Re: Broadwater Energy LLC Docket USC6-2005-21865

Broadwater LNG: Response to U.S. Coast Guard Letter Dated December 21, 2005:

Report for TransCanada PipeLines Limited
Report no.: 70014347
Rev 1, 13 February 2006

Figure 4-1 LNG Head above Water Leak

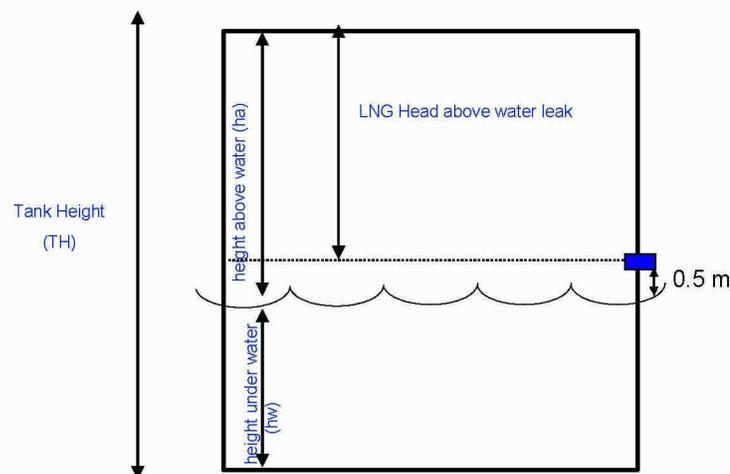
2. The Sandia Report is based on spill volumes of approximately 12,500 m³ of liquefied natural gas (LNG), which is approximately half of the contents of the cargo tanks on LNG carriers currently in service. This is not consistent with information regarding the capacity of the FSRU's LNG storage tanks provided by Broadwater Energy in the draft of Resource Report 13 that was submitted to the Federal Energy Regulatory Commission (FERC) in September 2005. It is also not consistent with the LNG storage tank capacity information provided in the DNV report. In addition, the DNV report does not establish whether the 15 meter initial height of the LNG above the breach that was used in the Sandia Report is appropriate for the FSRU or future generations of LNG carriers. Similarly, it does not establish the relationship between the dimensions of the LNG cargo tanks used for the Sandia Report and the expected dimensions of the LNG storage tanks on the FSRU or cargo tanks on future generation LNG carriers. As is apparent based on an examination of the equations in Appendix D of the Sandia Report, this information is a

required input for calculating factors related to LNG spill volumes and dispersion. In order to establish that the Sandia Report is applicable to the FSRU and 250,000 m³ LNG carriers, the modeling required by our letter of October 5, 2005 must be based on the volume of the FSRU's LNG storage tanks as well as the expected volume of cargo tanks on 250,000 m³ LNG carriers.

The DNV consequence modeling is based on site specific information while the Sandia study is based on generic data. The release rate is largely dependent on the amount of LNG head above the breach. A breach in both the FSRU and LNG carrier has been assumed to occur just above the water line. This assumption results in the largest LNG head and release volume and consequently the most conservative results. A simplification of the LNG head in a tank is illustrated in Figure 4-1.

The Broadwater project is currently considering an FSRU with eight tanks that each hold a volume of approximately 45,000 m³ of LNG. The LNG carriers that unload at the Broadwater facility may vary in size. This study attempted to be conservative in its assumptions; therefore, one of the largest sized carriers was chosen as a base case (250,000 m³ carrier with six storage tanks). The tank volumes, release volumes and LNG head that have been used as the basis for the Broadwater site specific evaluations are presented in Table 4-1, together with the data use in the Sandia Report.

As can be seen from Table 4-1, Sandia assumed that 50% of the tank volume would be released. DNV calculated the release volume based on the amount of draft when the vessel is fully loaded and the LNG head above the release. This resulted in a larger release volume than assuming a uniform 50% of the volume is released.

Figure 6-1 Location of NCDC nearest to LNG Carrier Route and FSRU

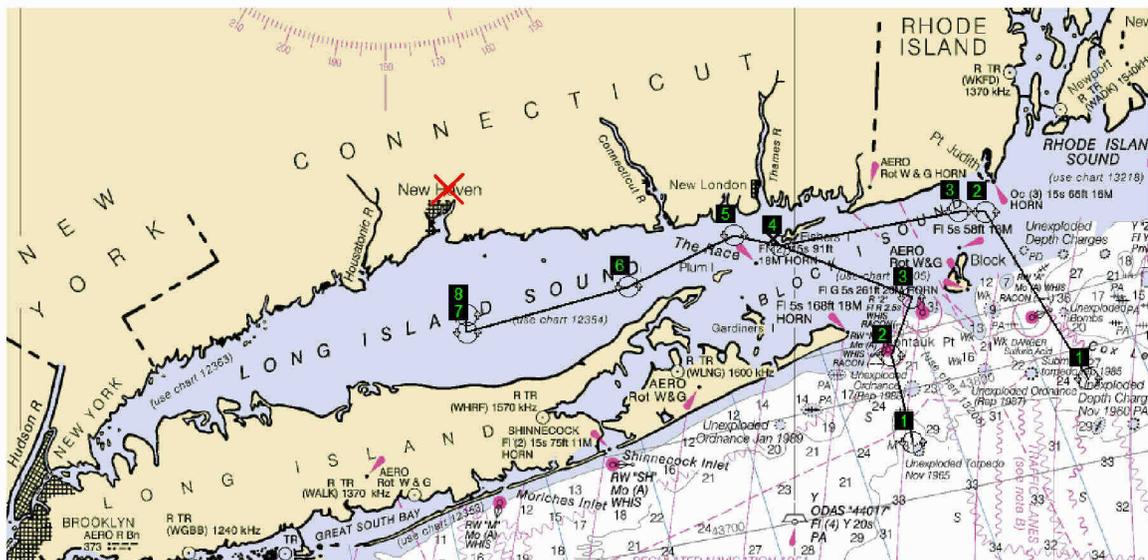
4. Although we concur with your assessment that more stable atmospheric conditions do result in larger dispersion distances than unstable conditions, e.g., hurricanes or Northeastern gales, it is noted that the dispersion modeling was conducted using atmospheric data for Baltimore, Maryland. This is not acceptable. As stated in our letter of October 5, 2005, the vapor cloud dispersion modeling should be based on "site specific, seasonal environmental and weather factors..." Therefore, you must conduct this modeling using atmospheric data for central Long Island Sound.

DNV has acquired site specific weather data from the National Climatic Data Center (NCDC). The closest weather data station to the proposed FSRU and LNG Carrier Route locations that provides stability class information was the New Haven, Connecticut airport. New Haven is marked by a red “X” in Figure 6-1 and an approximation of the proposed LNG carrier route and FSRU location are drawn as black lines.
